OUR REF: P3570.750-02
YOUR REF:

15 September 2011

**PREFERRED PROJECT REPORT FOR A MIXED USE DEVELOPMENT AT
78-90 OLD CANTERBURY ROAD, LEWISHAM (MP08_0195)**

Figure 1. Excerpt from Council's adopted dMLEP 2011
Land Zoning Map Sheet LZN_001

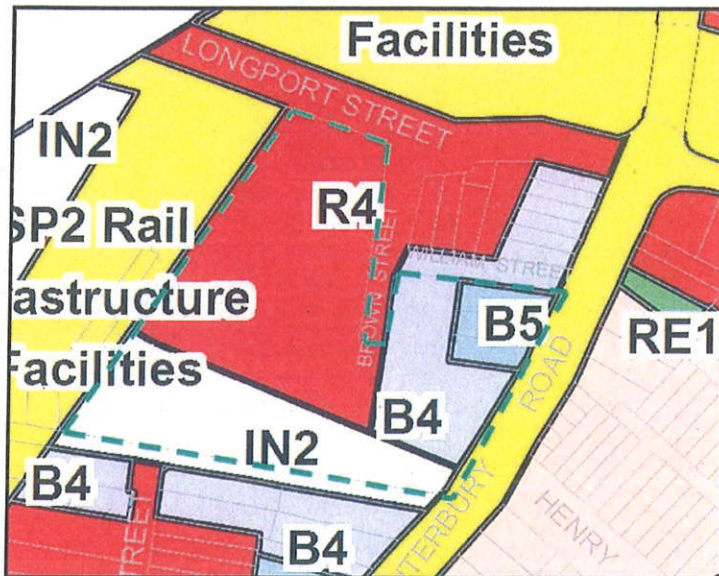
The PPR response to Council's zoning provisions analysis states:

Under the exhibited draft, the area adjacent to the northern edge of Hudson Street appears not to have a defined zoning in the draft LEP maps. However the remainder of the subject site is affected by the R4 High Density Residential, B4 Mixed Use and B5 Business Development zones.

As shown in Figure 1 above, the area adjacent to the northern edge of Hudson Street is zoned IN2 Light Industrial under the adopted dMLEP 2011, which is the same as the zoning in the exhibited dMLEP 2010. The PPR claim that this area does not have a 'defined zoning in the draft LEP' is incorrect. The PPR concept plan proposes that the majority of the retail and shop top/dual use uses will be located within this zone, are prohibited uses under the zoning provisions applying to the land under the dMLEP2011, and which was intended as publically accessible open space in Council's masterplan. As a result the quality of the PPR open space along this green corridor, is less usable and of lower quality than that proposed in Council's masterplan, and is discussed further in this report.
